July 2020

# Consultation on proposed changes to New Covent Garden Market Redevelopment

NEW  
COVENT  
GARDEN  
MARKET

**Figure 4: Increasing the vehicle loading areas in Buildings A and C**

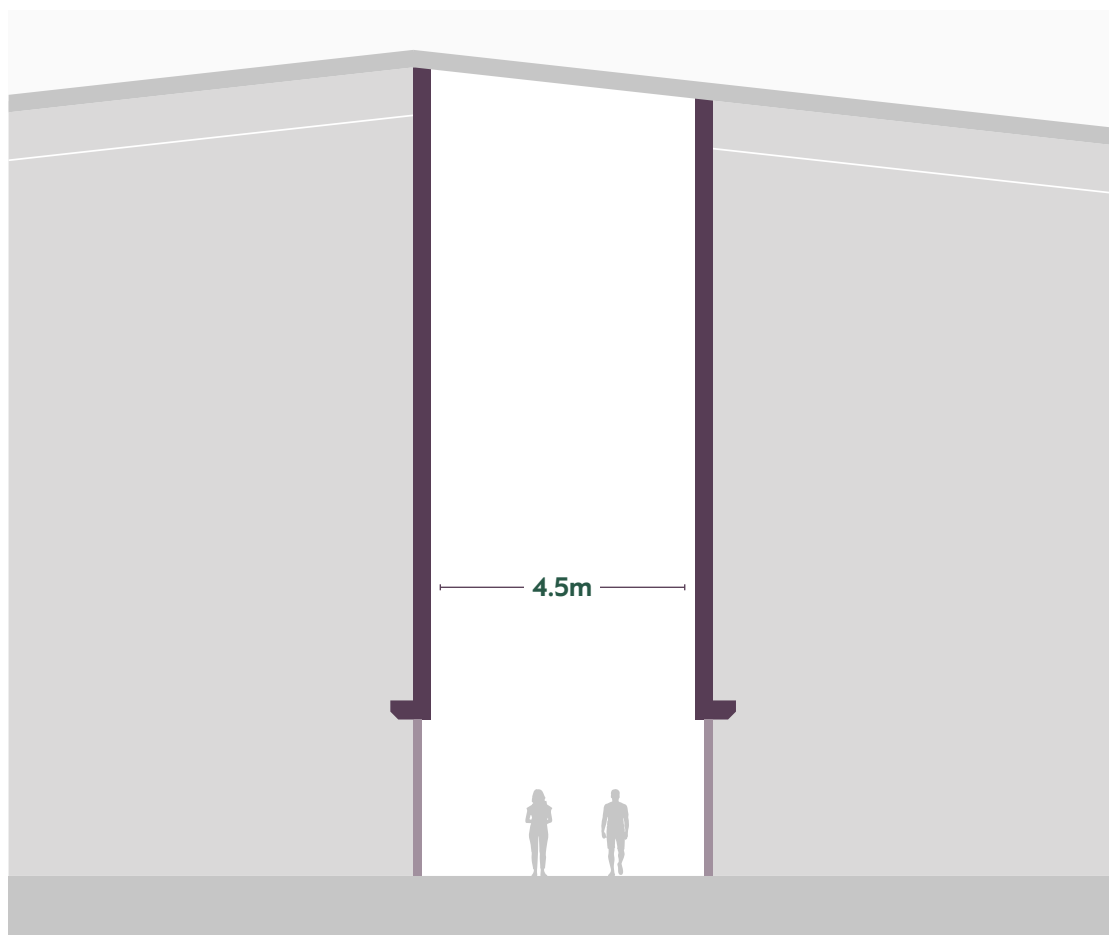
CGTA raised concerns that the vehicle loading areas as originally planned were not large enough. CGTA want to ensure that more vans could access and park on the hardstanding. Under the original plans there was space for two vans measuring approximately 7.5 metres outside each unit. Under the revised proposals there will be additional space allowing for a further row of vans outside the units. It is important to note that the vehicle loading area is to be used only for vehicle loading and unloading. It is not to be used for storage.

The existing design specified that the vehicle loading area outside each unit would extend approximately 22 metres outwards from the front of the unbuilt part of Building A (west side) and Building C (east side) and 24 metres outwards from the front of unbuilt Building A (east side) and Building C (west side). Having considered CGTA's concerns about the length of the loading areas from the front of the units, the proposal is to increase those distances from 22 metres to 31 metres and from 24 metres to 33 metres respectively as explained in the next paragraph.

The proposed redesign of the units comprises a retraction of the lower half of the front of both sides of each building by approximately 9 metres. The upper half would remain as shown in the existing plans, creating an "overhang", in which tenants could construct a mezzanine.

In addition, as part of the redesign, the number of columns along the whole length of each building, which provide structural support for the overhanging part, will be reduced. They are currently shown as being spaced at 6 metre intervals. The aim is to remove every second column to allow better manoeuvrability of the vans backing up under the new recess created by the retraction of the lower half of the building.

The proposal for the retracted lower frontages is illustrated by the cross-sectional “before and after” drawings of a typical unit at **Figure 4**.

- An overall average increase in the vehicle loading area from 136.4 m<sup>2</sup> to 198.4 m<sup>2</sup> outside each unit in the unbuilt part of Building A (west side) and in Building C (east); and an increase from 148.8 m<sup>2</sup> to 204.6 m<sup>2</sup> in unbuilt A (east) and in C (west).
- An overall average decrease in area from 196 m<sup>2</sup> to 142 m<sup>2</sup> of ground floor space in each unit in the unbuilt part of Building A and in Building C, caused by the setting back of the front of the buildings.

### Figure 5: The Buyers' Walk in the unbuilt part of Building B

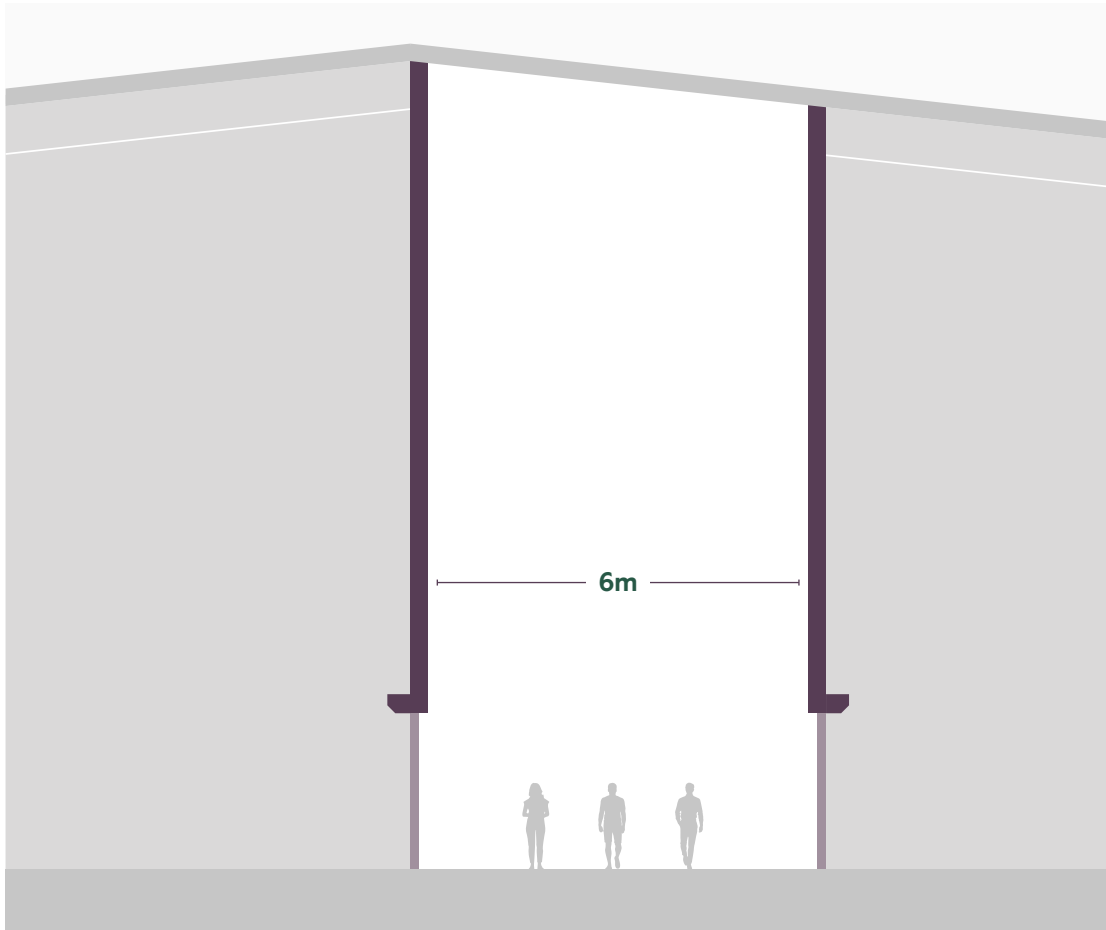
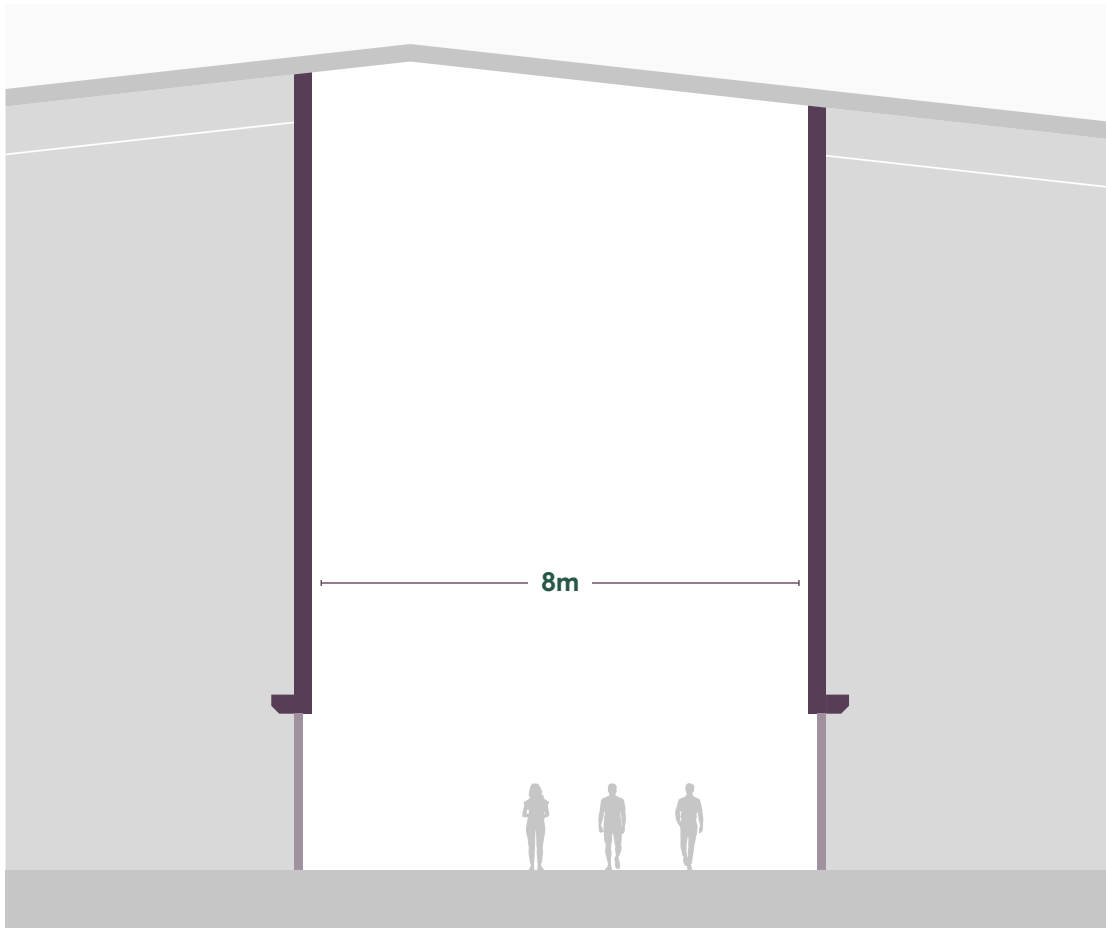
Under the existing proposals (and in that part of Building B that has already been constructed), the width of the Buyers' Walk is approximately 4.5 metres. The proposal is to increase that width to a minimum of 6 and maximum of 8 metres in that part of Building B that is yet to be constructed.

The "before and after" cross-sections in **Figure 5** show the effect of the proposed change on the units in two different scenarios; a widening of the Buyers' Walk to 6 metres and a widening to 8 metres. If the Buyers' Walk were widened, it might result in a small reduction in the ground floor area of a typical unit in the unbuilt part of Building B.

The additional width could result in the possibility of tenants being able to show some of their produce in the area immediately adjacent to their units on Buyers' Walk. This is a matter on which the CGMA would welcome views of consultees. The proposal is that tenants whose units back on to Buyers' Walk would be able to use it to display goods, as long as they keep access and egress clear, do not obstruct shutters, and display only in designated areas. CGMA's preliminary view is that a minimum of 2 metres width should be kept clear of obstructions to enable the free flow of pedestrians.

There would need to be discussions with the Developers about this proposal because their agreement would be required for the changes. If the detailed design were to show that there were technical or financial reasons why the Buyers' Walk should not be increased to 8 metres, or the Developers were for some other reason unable to implement the change, then consideration would be given to a smaller extension, but the ideal position agreed in principle by CGMA and CGTA is that the total width should not be smaller than 6m.

**Figure 6: Building canopies on the unbuilt part of Building B**  
Original planned layout

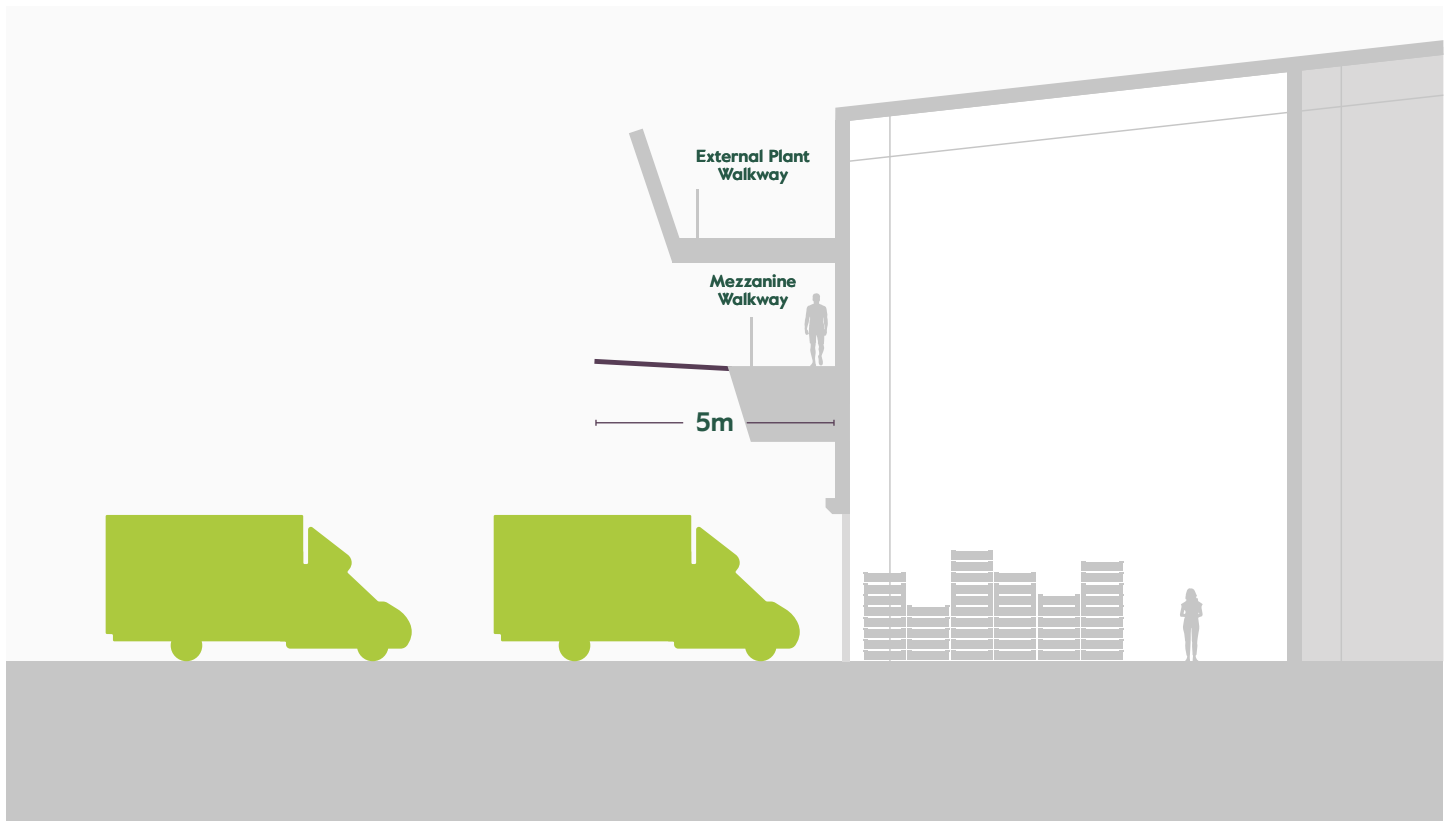
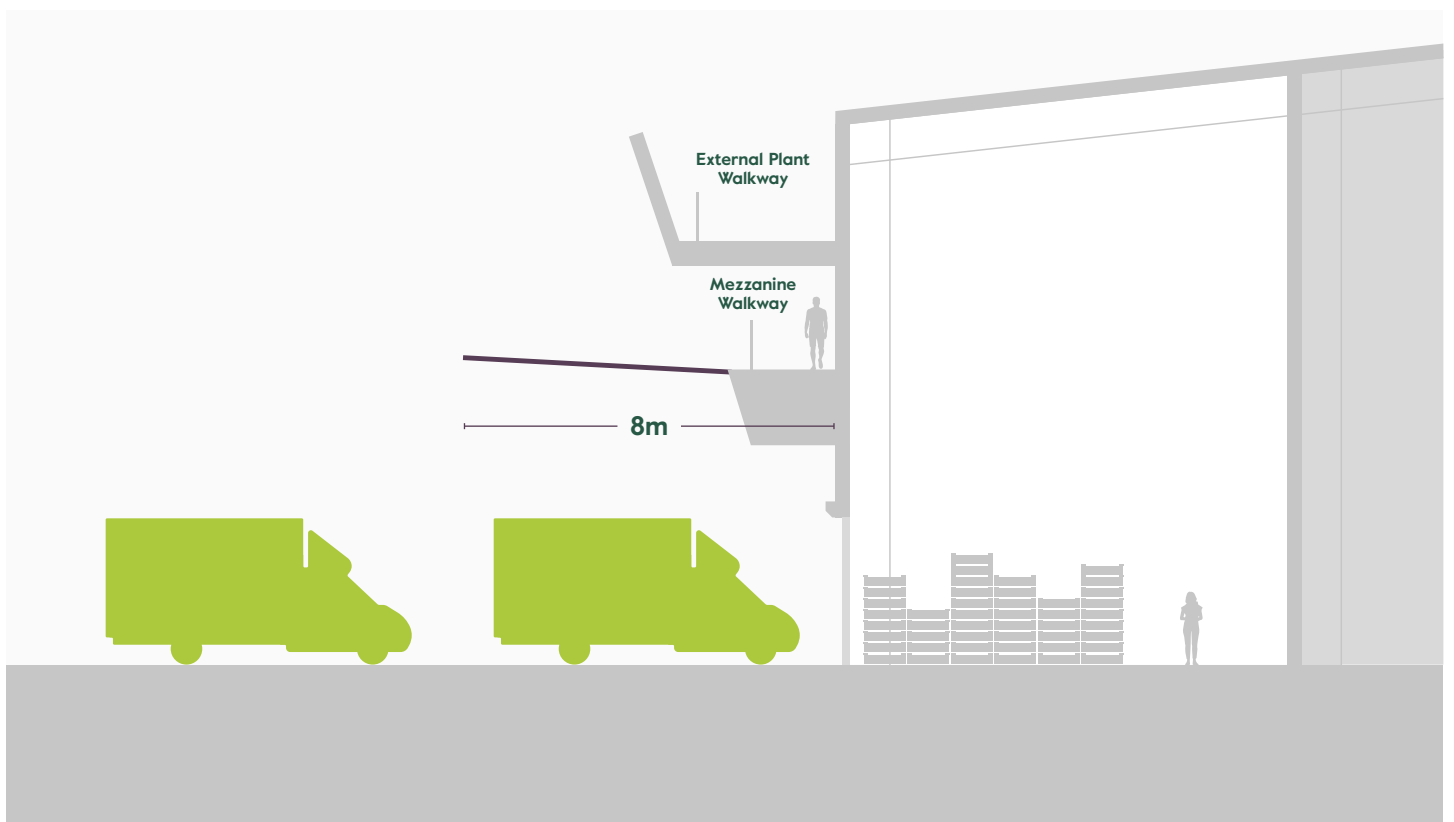
In the existing design, there would be a canopy running along the whole length of both sides of Buildings A, B and C, the purpose of which is to provide shelter from the weather. The current design for all three buildings shows the canopy extending to approximately 5 metres out from each building out into the vehicle loading areas.

The proposed change is to increase the depth of the canopies on that part of Building B which is yet to be constructed by approximately 3 metres. This will mean that instead of the canopies extending out by 5 metres it will be 8 metres.

The effect of the proposal on a typical unit is illustrated on the section at **Figure 6**.
